DATE: FEBRUARY 14, 2014
TO: HONOURABLE MAYOR & MEMBERS OF COUNCIL
FROM: JOHN MACKENZIE, COMMISSIONER OF PLANNING
RE: COMMUNICATION - COUNCIL MEETING - FEBRUARY 18, 2014
ITEM #10, COMMITTEE OF THE WHOLE - FEBRUARY 4, 2014

**ZONING BY-LAW AMENDMENT FILE Z.12.020
DRAFT PLAN OF SUBDIVISION FILE 19T-12V002
MAPLEQUEST (VAUGHAN) DEVELOPMENTS INC.
WARD 3 - VICINITY OF WESTON ROAD AND MAJOR MACKENZIE DRIVE**

1. THAT the Report of the Commissioner of Planning and Director of Development Planning, dated February 4, 2014, with respect to Zoning By-law Amendment File Z.12.020 and Draft Plan of Subdivision File 19T-12V002, be amended as follows:

Revised Attachment

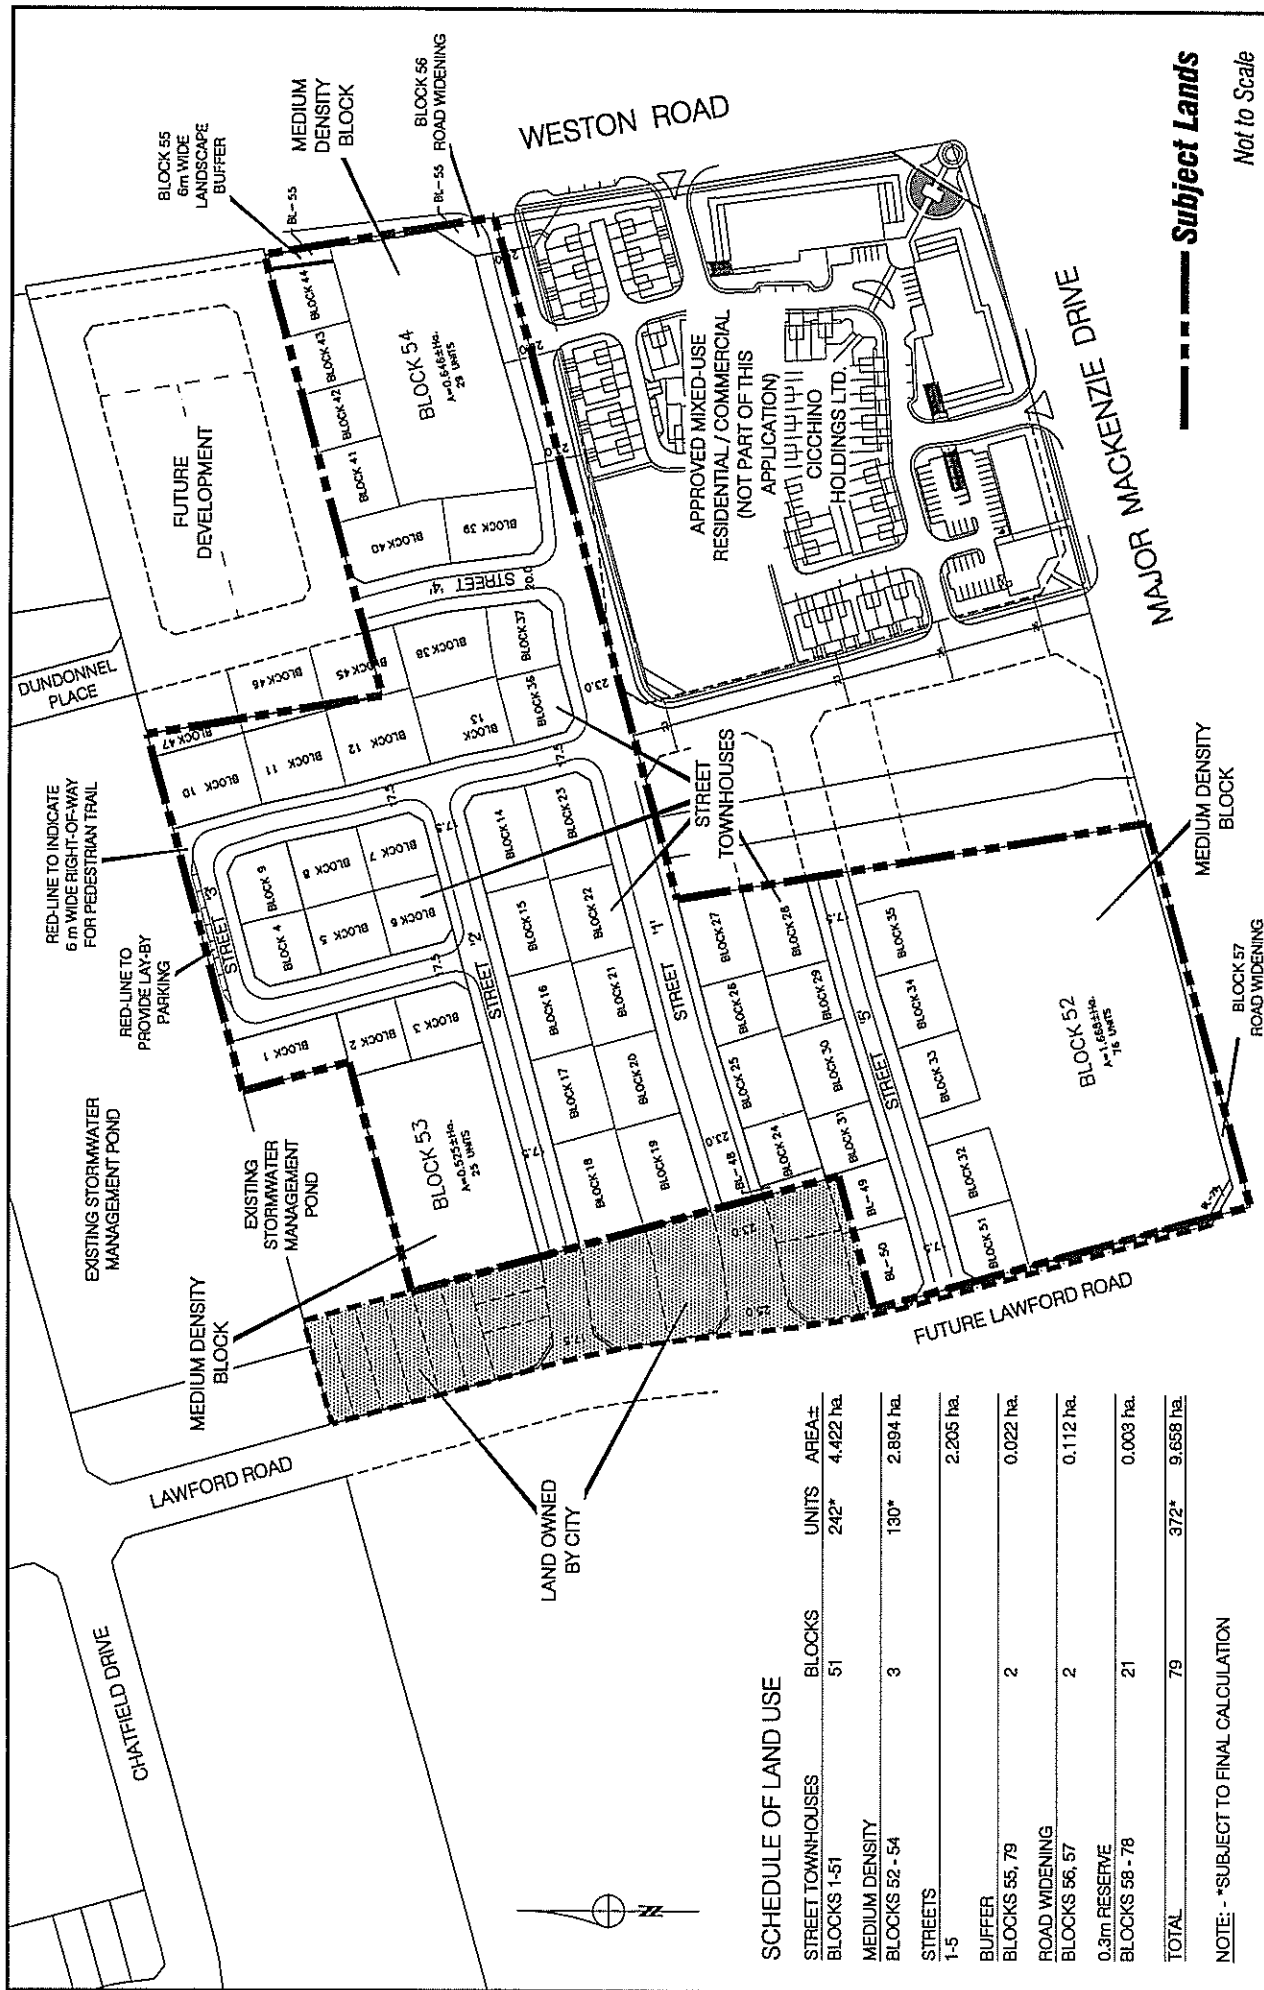
- "1. The Plan shall relate to the Draft Plan of Subdivision, prepared by KLM Planning Partners Inc., dated January 17, 2014, as red-line revised (February 18, 2014), incorporating the following red-line revisions:

- a) modify the width of the east-west extension of Street "3" from a 17.5 m wide local road to a 15 m wide single-loaded road, in order to accommodate lay-by parking spaces within the remaining 2.5 m width adjacent to the stormwater management facility (Block 193, Registered Plan 65M-4145); and,

- b) include a 6 m wide right-of-way for a pedestrian trail from the Draft Plan of Subdivision into and through the stormwater management facility lands (Block 193, Registered Plan 65M-4145)."

Revised Attachment

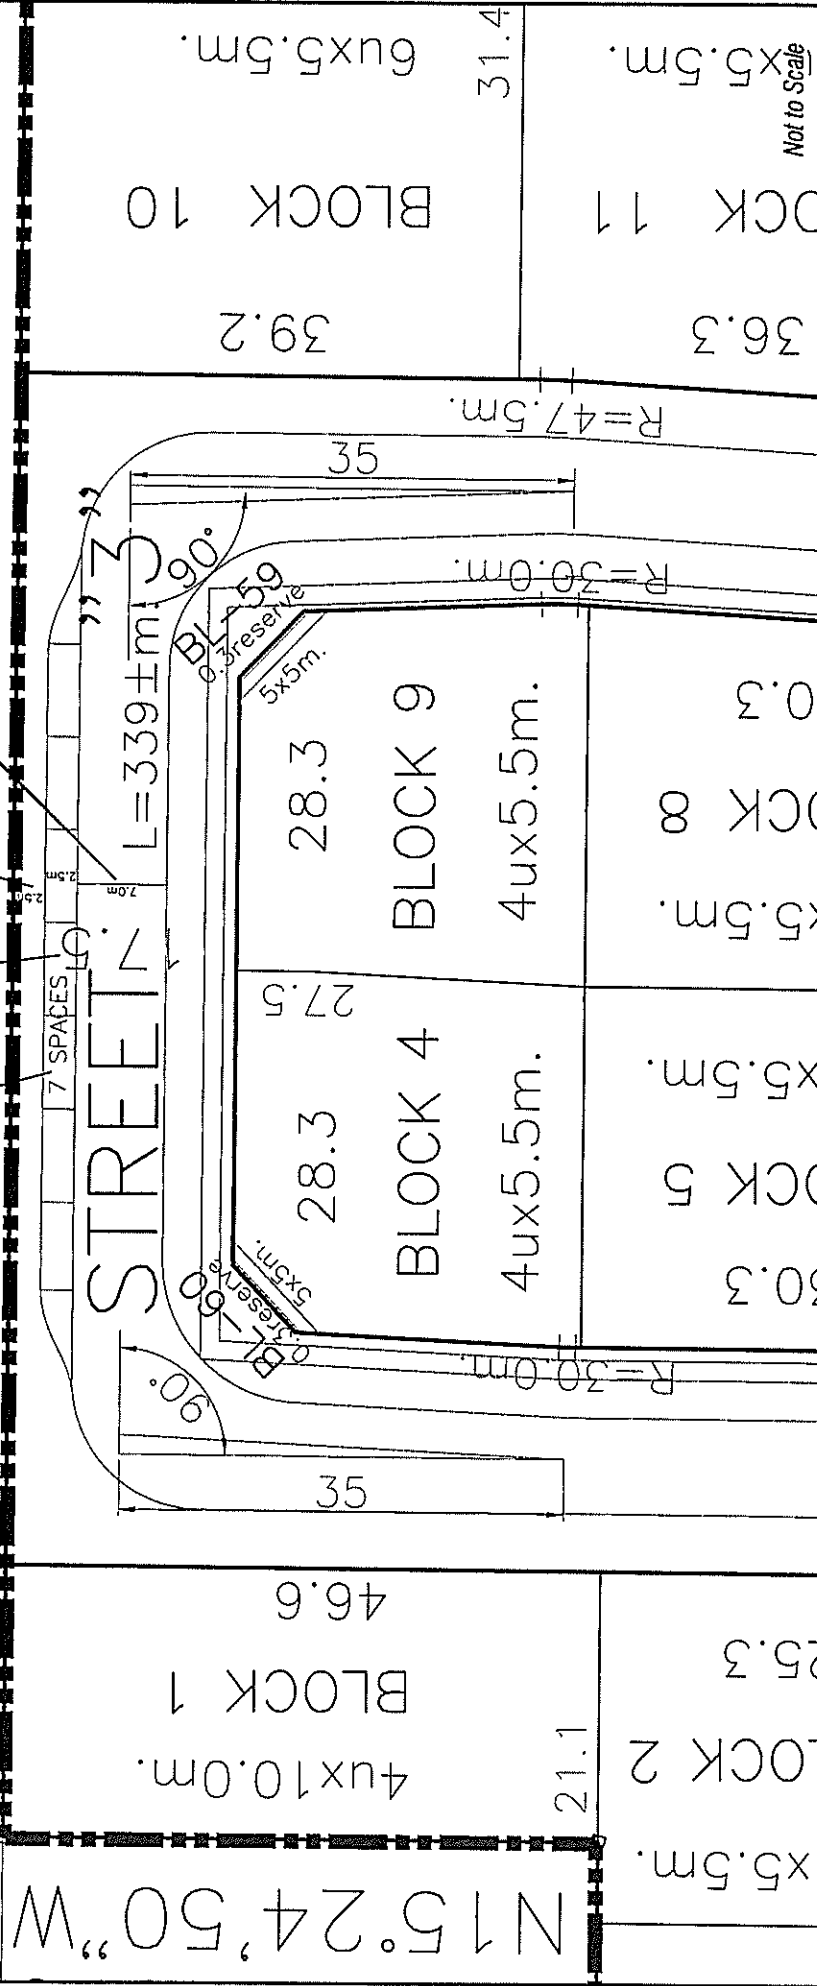
MODIFY 17.5 m WIDE LOCAL ROAD
TO 15 m WIDE SINGLE - LOADED ROAD

7 LAY - BY PARKING SPACES
(2.5 m DEPTH - 6.7 m WIDTH)

4 m WIDE BOULEVARD
MODIFIED TO 2.5 m WIDE
BOULEVARD

Accordingly, the road right-of-way width of Street "3" in the Draft Plan of Subdivision can be reduced from 17.5 m to 15 m for the portion of the road that is single-loaded resulting in the remaining 2.5 m of the road right-of-way being dedicated for lay-by parking usage as shown on Attachment #7 to this Communication. Specifically, the 8 m wide pavement is reduced to a 7 m wide pavement and the 4 m wide boulevard is reduced to a 2.5 m wide boulevard. Seven lay-by parking spaces with a width of 2.5 m and a length of 6.7 m can be accommodated within Street "3", as shown on Attachment #7 to this Communication. Recommendations included in this communication to red-line revise the Draft Plan of Subdivision 19T-12V002 and Conditions #1 and #6 in Revised Attachment #1 to this Communication, modify the width of the road right-of-way from 17.5 m to 15 m to accommodate the lay-by parking.
